SUBJECT: Savannah River Site's Responses to the Regulatory Comments on the P-Area Groundwater (PAGW) Operable Unit (OU) Zero Valent Iron Permeable Reactive Barrier (ZVI-PRB) Removal Action (U) - April 2022 through March 2023 (SRNS-RP-2023-01281, Revision 0, March 2024), SEMS Number: 81

**SRS Responses to SCDES Comments on the Effectiveness Monitoring Report (EMR) for
the P-Area Groundwater (PAGW) Operable Unit (OU) Zero Valent Iron Permeable
Reactive Barrier (ZVI-PRB) Removal Action (U), April 2022 Through March 2023, SEMS
Number: 81, SRNS-RP-2023-01281, Revision 0, March 2024
Savannah River Site, Aiken, South Carolina**

**SRS Responses to USEPA Comments on the Effectiveness Monitoring Report (EMR) for
the P-Area Groundwater (PAGW) Operable Unit (OU) Zero Valent Iron Permeable
Reactive Barrier (ZVI-PRB) Removal Action (U), April 2022 Through March 2023, SEMS
Number: 81, SRNS-RP-2023-01281, Revision 0, March 2024
Savannah River Site, Aiken, South Carolina**

Figure CR-1. Revised Figure of Effectiveness Monitoring Plan Locations

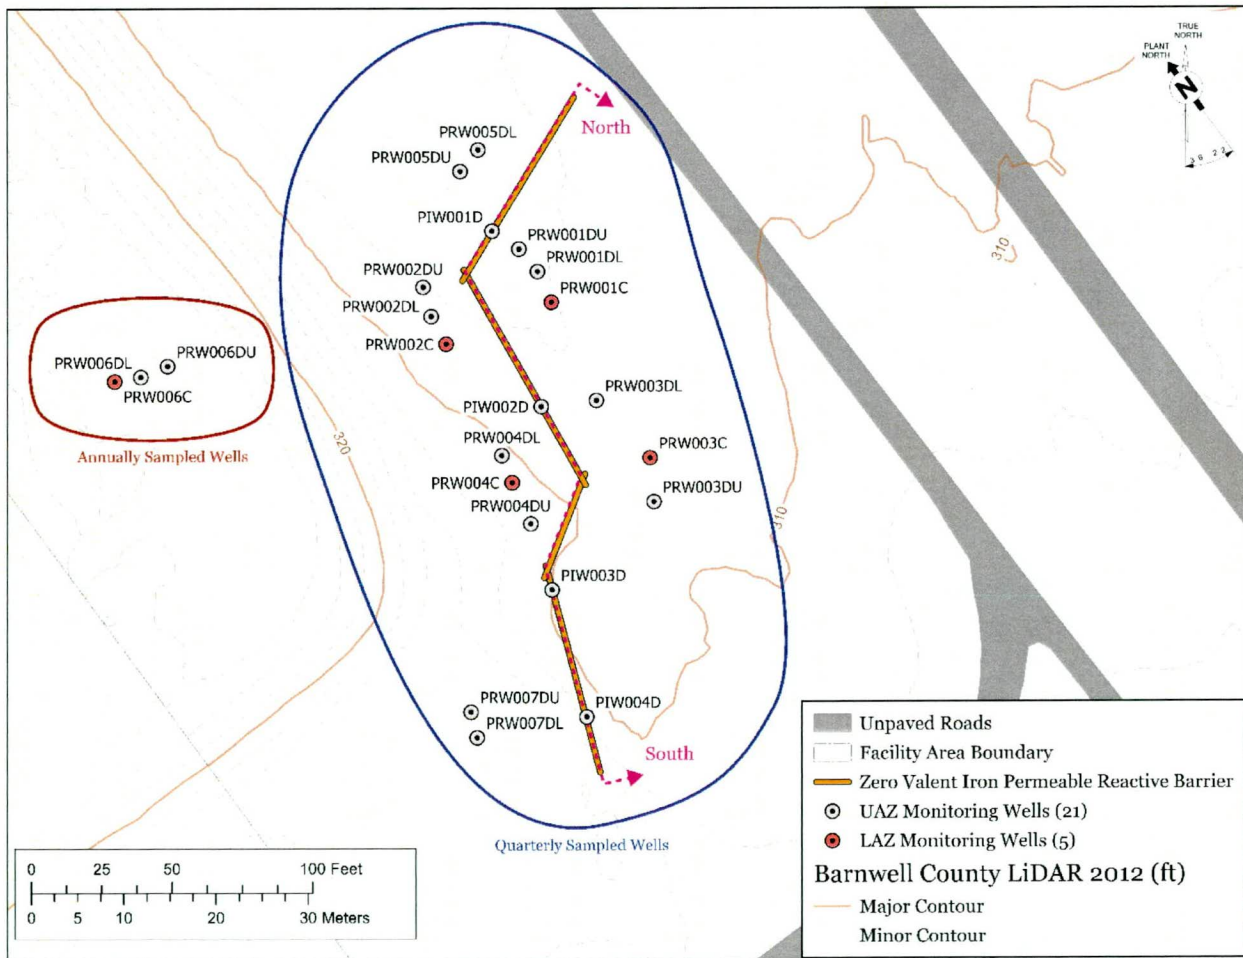
- Figure 7, Effectiveness Monitoring Plan Locations, Page 44:** A red oval and a larger blue oval shape are depicted in the figure, however, their meaning is not defined in the figure legend. *Please revise the figure to define the red and blue oval shapes.*

The figure depicting monitoring well locations will be revised to define the red and blue polylines more clearly. What the lines represent will be defined by “Annually Sample Wells” and “Quarterly Sample Wells” below the shapes and will be color coded accordingly. An example of the figure that will be used in future EMRs is included with these responses as Figure CR-1.
